Official Transcript of Proceedings
NUCLEAR REGULATORY COMMISSION

Title: Advisory Committee on Reactor Safeguards
Power Uprates Subcommittee: Open Session

Date: Wednesday, December 14, 2011

SUBCOMMITTEE ON POWER UPRATES

Review Results

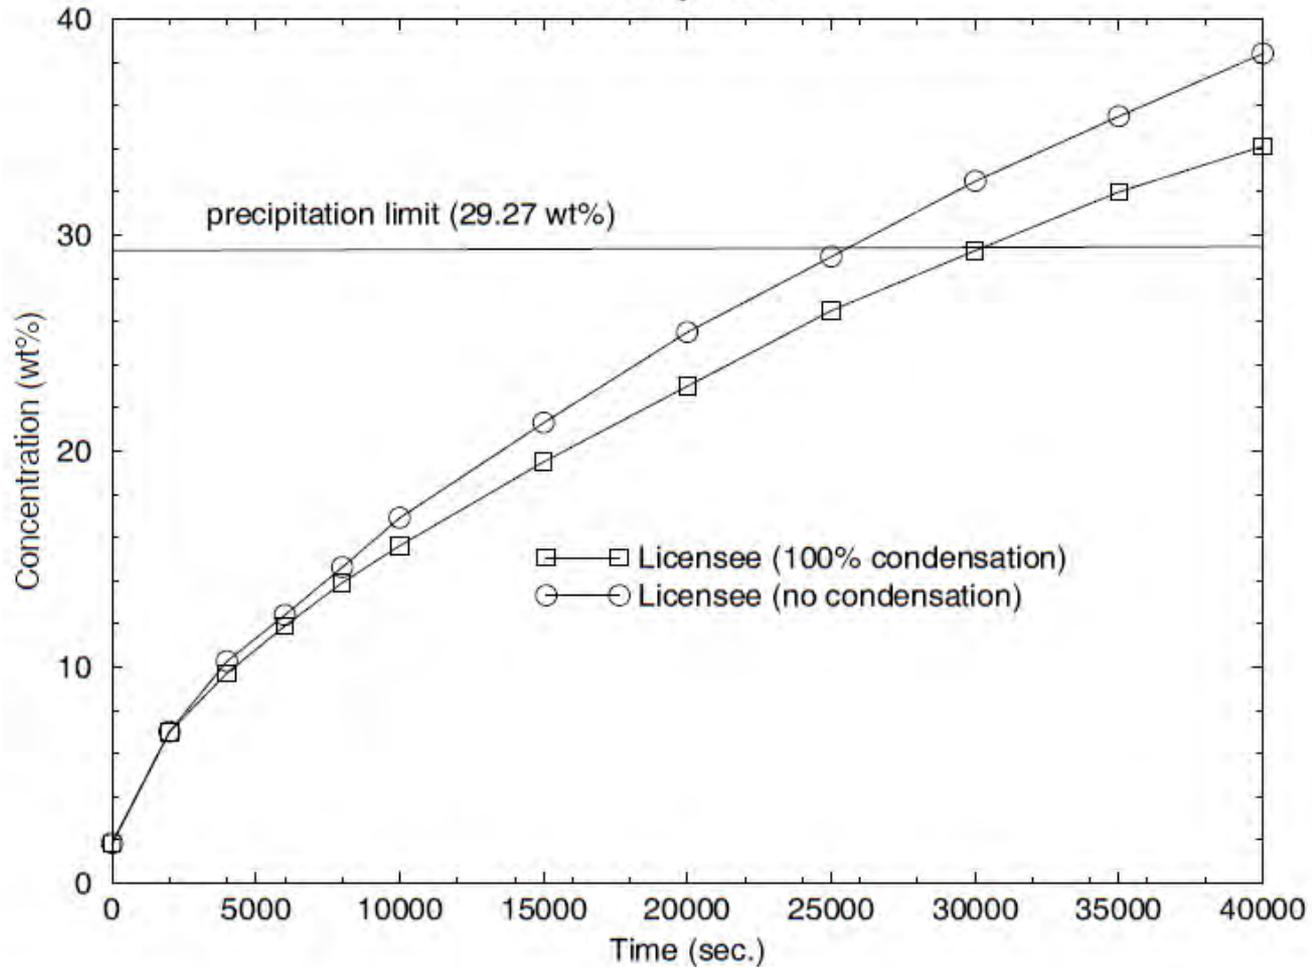
- Precipitation timing:
 - ❖ 8.3 hrs (licensee)
 - ❖ 6.7 hrs (staff)
- Staff questioned licensee assumed 100% condensation of core generated vapor
- Licensee recalculated precipitation time (no cond)
 - ❖ Produced earlier precipitation time of 7.1 hrs (vs 8.3 hrs)
 - Set switch to hot leg injection at 5.5 hrs
 - Provides more than one hr margin to precipitation
 - ❖ All cold leg HHSI switched to hot leg at 5.5 hrs
 - ❖ Operators required to perform switch in less than 3 min
 - ❖ A delay of 27.8 min will cause core to uncover and PCT to reach 2200 F
 - ❖ Licensee demonstrated 2 min for operators to perform switch during simulator training exercises
